Technical Memorandum

TO: Mr. Alan Day, General Manager
Brazos Valley Groundwater Conservation District

SUBJECT: Review of RH2O LLC Simsboro Aquifer Evaluation Report

DATE: September 1, 2023

Figure 2. AGS This Analytical Simulated Drawdown After Proposed RH2O Pumping of 8,130 ac-ft/yr for 10-Years

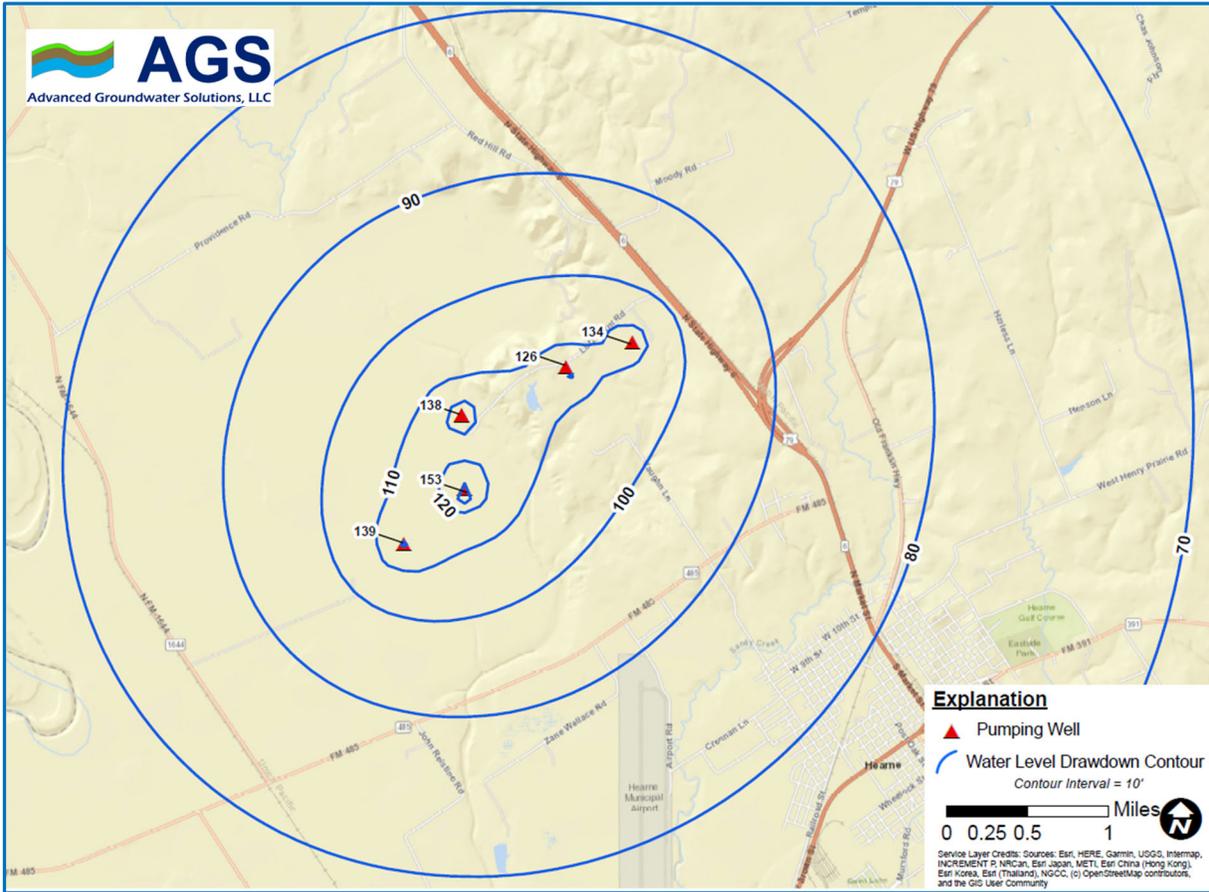
AGS was able to generally recreate the 1-year simulation results of the TGI analytical modeling. The TGI 10-year analytical simulation appears to underestimate the drawdown compared to simulations performed by AGS using the aquifer parameters as described above. Simulated drawdown could be less if TGI used a larger storage value in the 10-year simulation. Figure 2 below shows the estimated AGS analytical modeling drawdown contours that result from pumping 8,130 ac-ft/yr for 10-years.

Table 3 below provides a summary of the AGS simulated drawdown estimates at 1-foot from each of the proposed RH2O wells after pumping 8,130 ac-ft/yr for 1-year and 10 years.

Figure 3. Projected DFC Water Level Change at Proposed RH2O Well 1

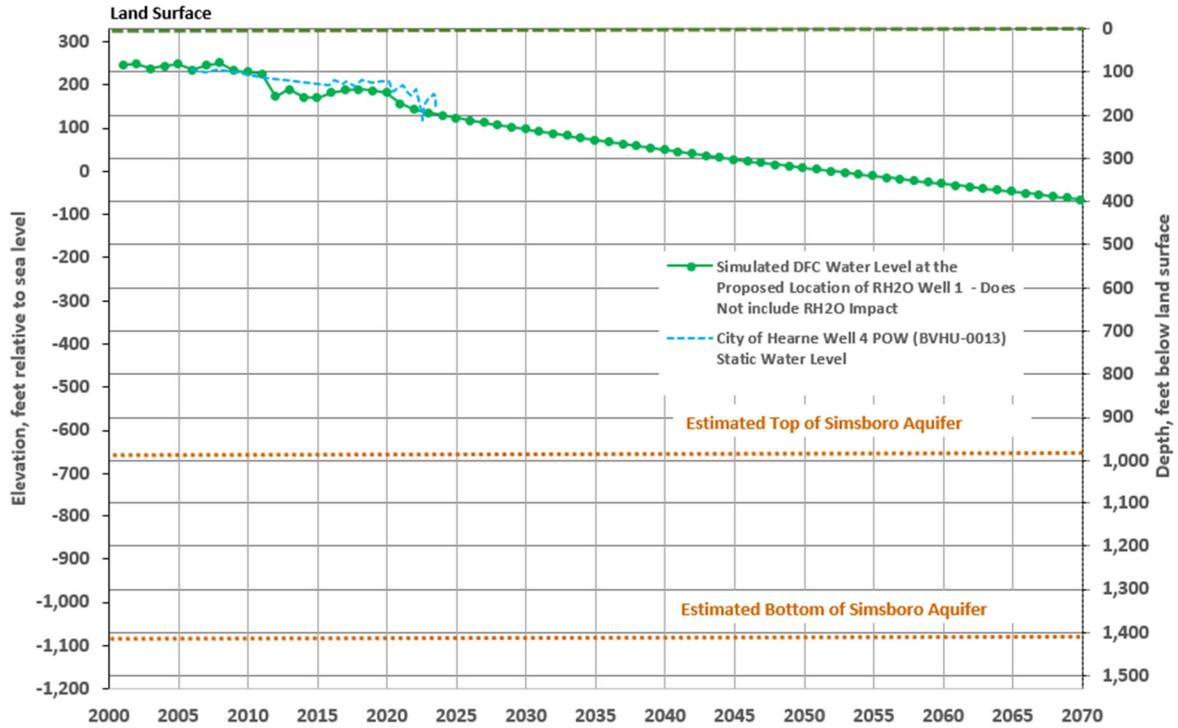
Water levels available from the City of Hearne Well 4 (POW) (BVGCD Permit BVHU-0013) are shown on Figure 3. The well screen sands of the Simsboro Aquifer in the depth interval of about 1,221 to 1,425 feet below land surface. BVHU-0013 is located about 1.7 miles south of proposed RH2O Well 1.

Available drawdown in wells in the Simsboro Aquifer will decline over time based on the DFC simulation. In other words, the line with green dots does not include the impact of the proposed RH2O wells. Although not evaluated or discussed in detail herein, these levels of water level decline in wells and artesian head decline in the aquifer will have some impact on vertical leakage, intercepted discharge, reduction in confined and unconfined storage, and potential flow directions in the aquifer. Pumping by the proposed wells will have some of the same type effects on the aquifer.

**Figure 9: 1-Year GAM
Drawdown Contours**

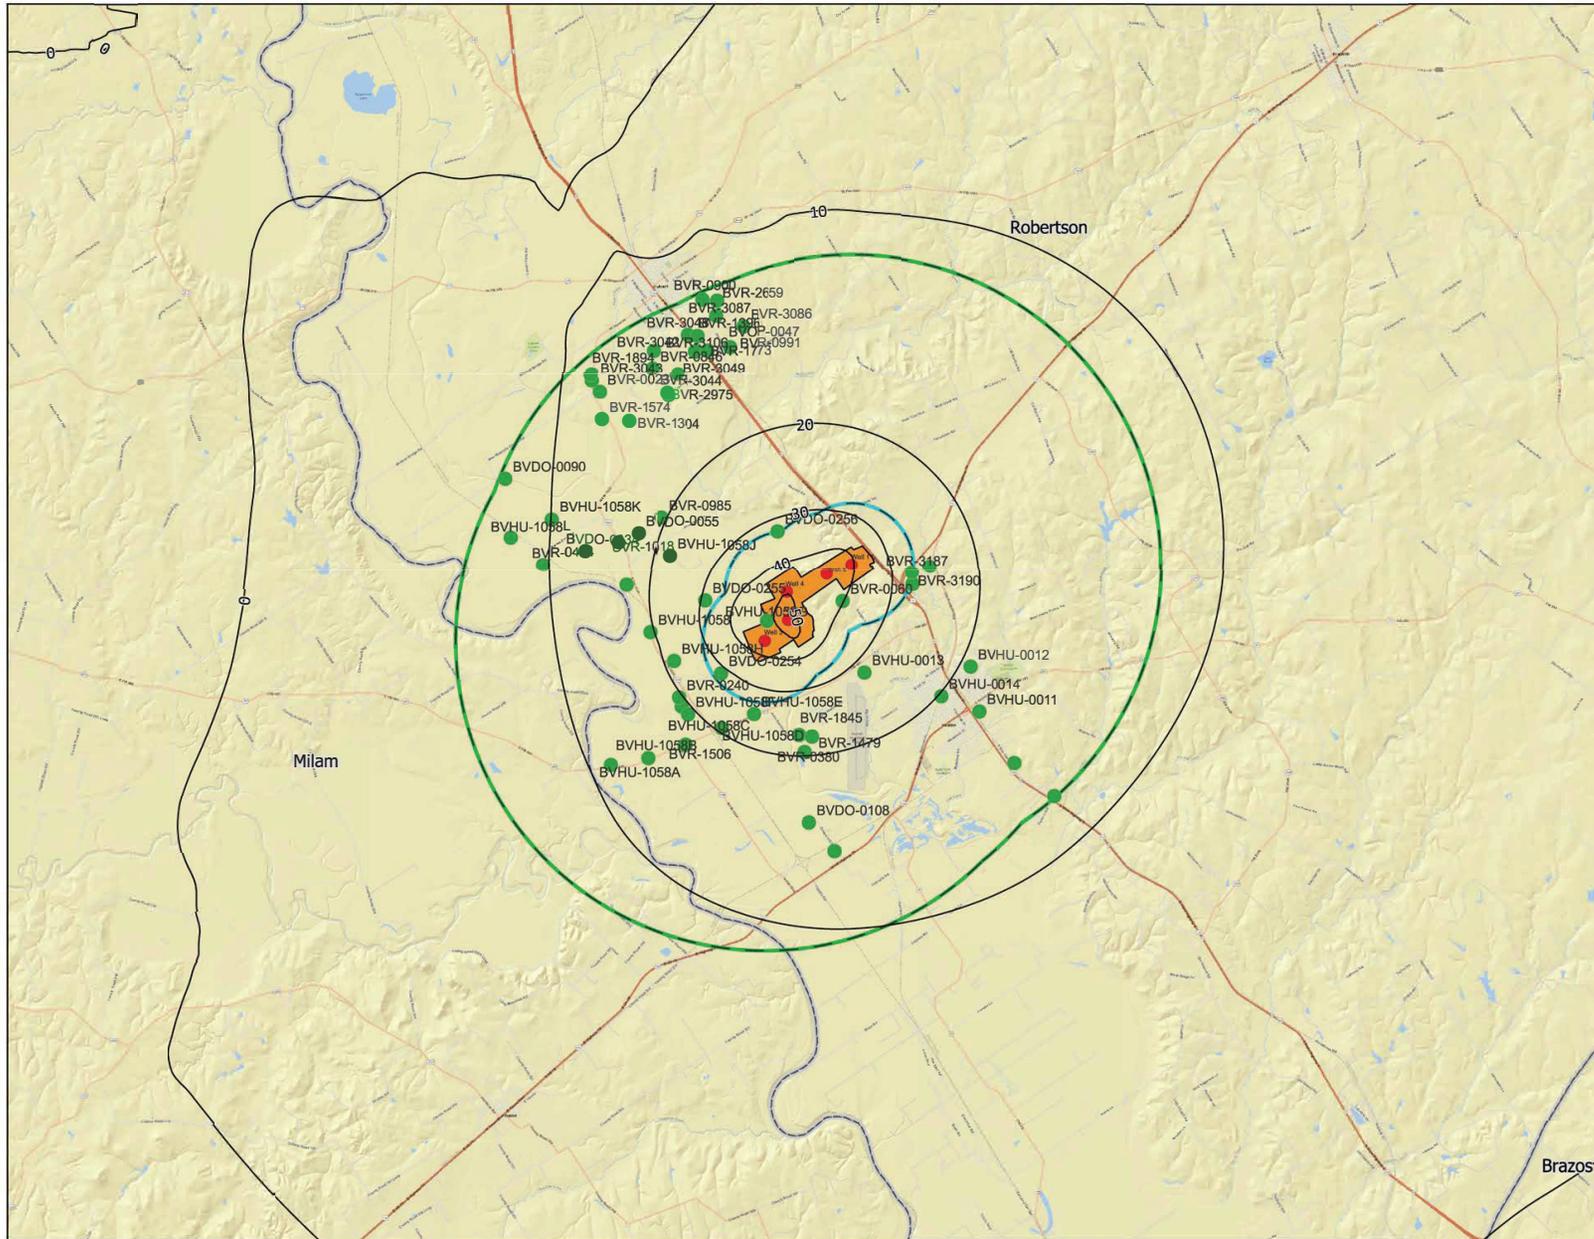
TGI used the TWDB Central Portion of the Sparta, Queen City and Carrizo-Wilcox Aquifer GAM to estimate drawdown that results from continuously pumping the proposed RH2O wells at a combined rate of 8,130 ac-ft/yr for 1 year and 10 years. A copy of the TGI 1-year and 10-year GAM simulated interference drawdown illustrations from the AER (TGI Figures 9 and 10) are attached to this memorandum. Tables 1 and 2 in the TGI AER shows GAM simulated 1-year and 10-year drawdown estimates at most BVGCD permitted and registered Simsboro wells within a 1-mile and 5-mile radius of the proposed RH2O wells. The TGI report did not discuss the GAM simulation methodology, but the TGI GAM model results appear to be reasonable based on AGS simulation verification runs.

The AGS GAM simulation results after 1 and 10 years of pumping 8,130 ac-ft/yr show about 8 to 18 feet of drawdown at 5 miles and about 30 to 38 feet of drawdown at 1 mile after 1-year of pumping and about 10 to 20 feet of drawdown at 5 miles and about 35 to 40 feet of drawdown at 1 mile after 10-years of pumping.

The GAM estimated drawdown contours near proposed RH2O wells appear to be influenced by faults included in the GAM, which are in the same general area as faults that have been mapped by GWC and AGS using local geophysical logs and other hydrogeologic data.
